Town of Hilton Head Island

Gateway Corridor Workshop

April 5, 2022

Review of SCDOT/Beaufort County Responses

BRIDGE SECTION - LOCAL ALTERNATIVE

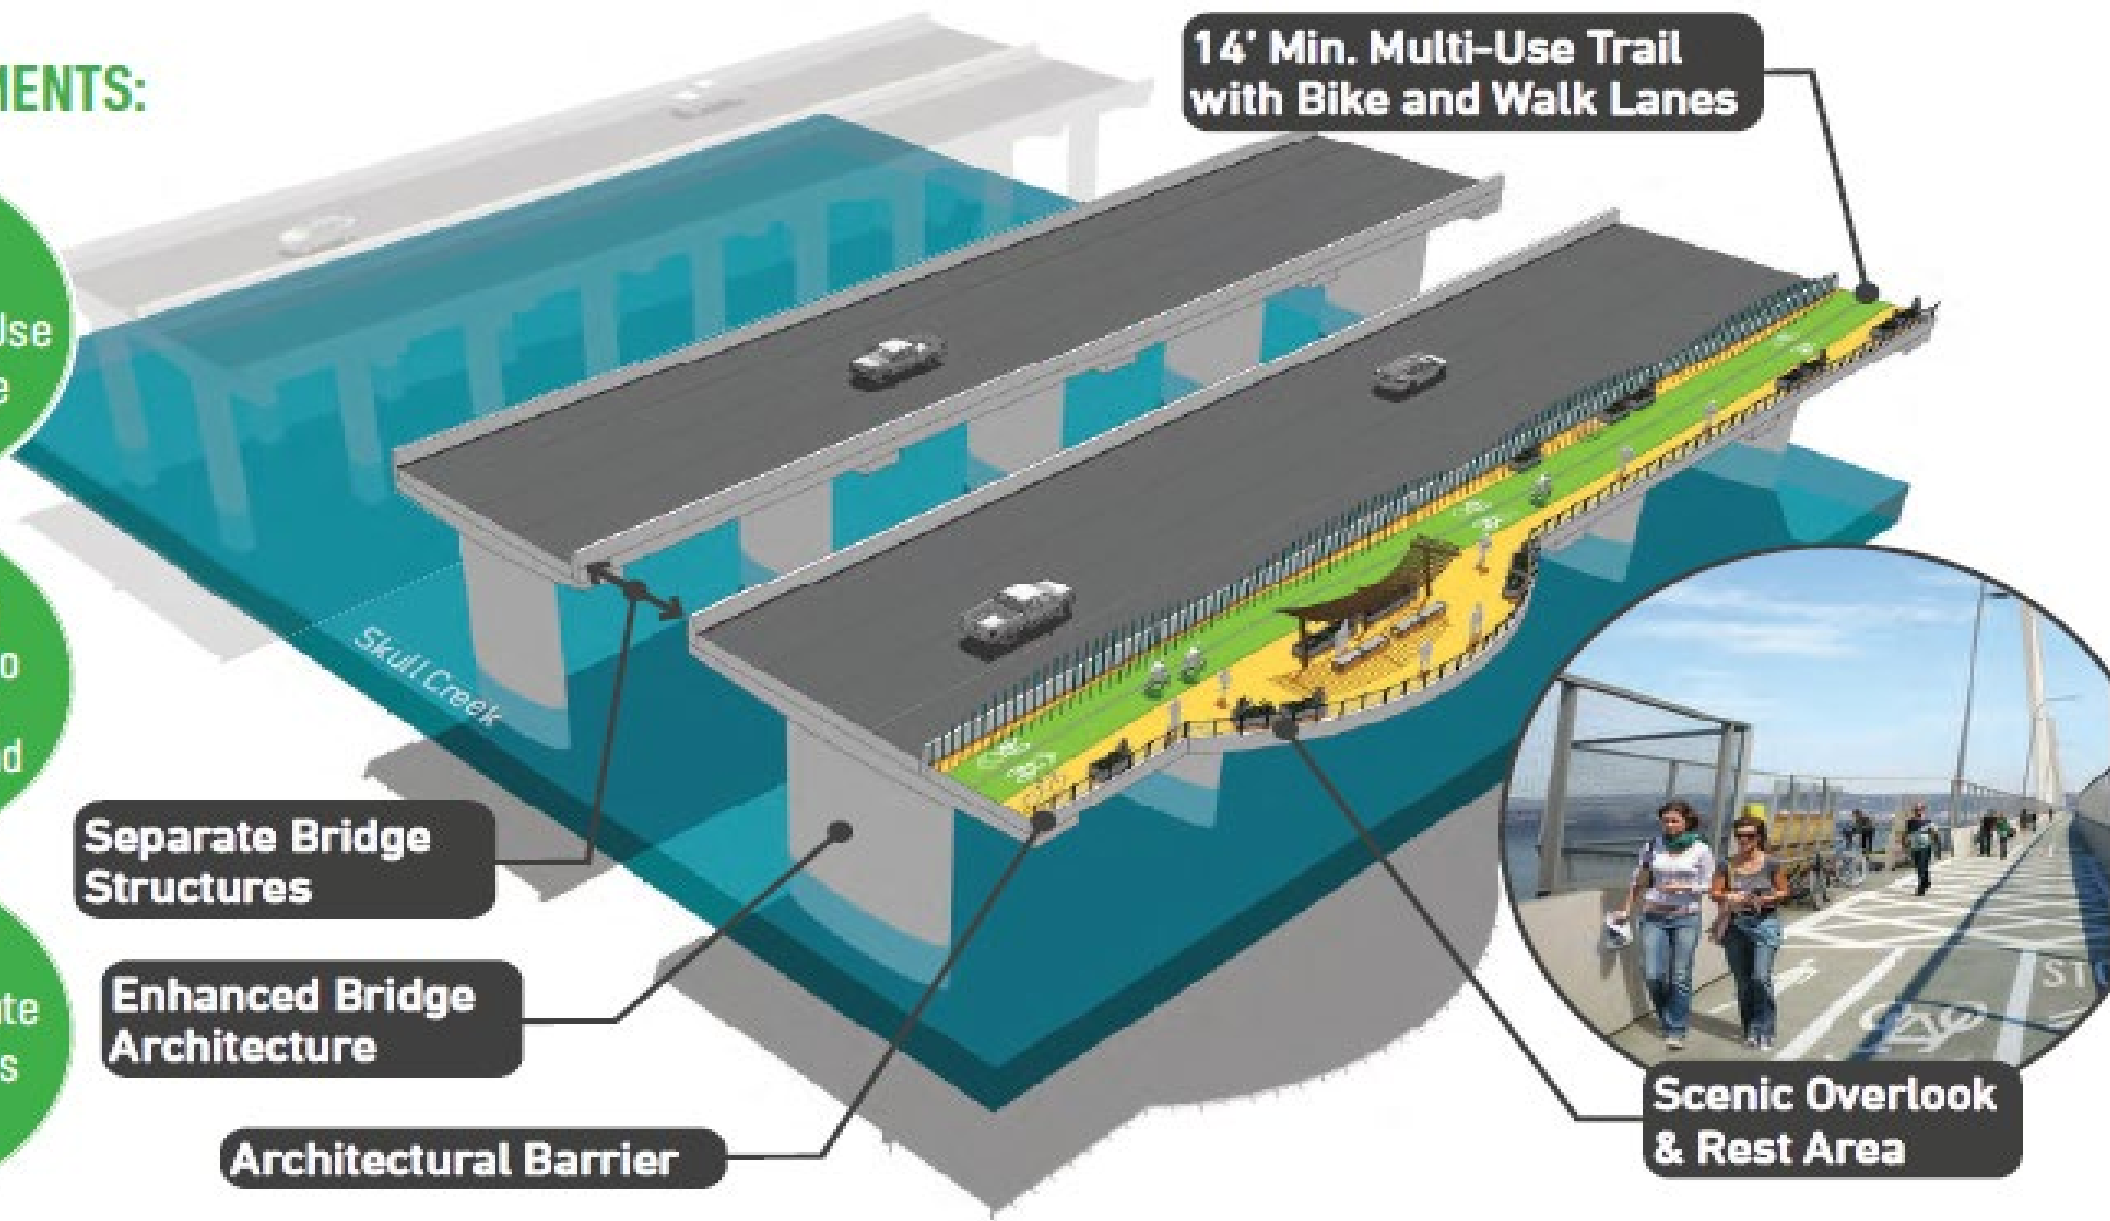
Widen &
Improve Multi-Use
Trail on Bridge

Improve Trail
Connections to
Mainland &
Pinckney Island

Explore Alternate
Bridge Designs

14' Min. Multi-Use Trail
with Bike and Walk Lanes

Separate Bridge
Structures

Enhanced Bridge
Architecture

Architectural Barrier

Scenic Overlook
& Rest Area
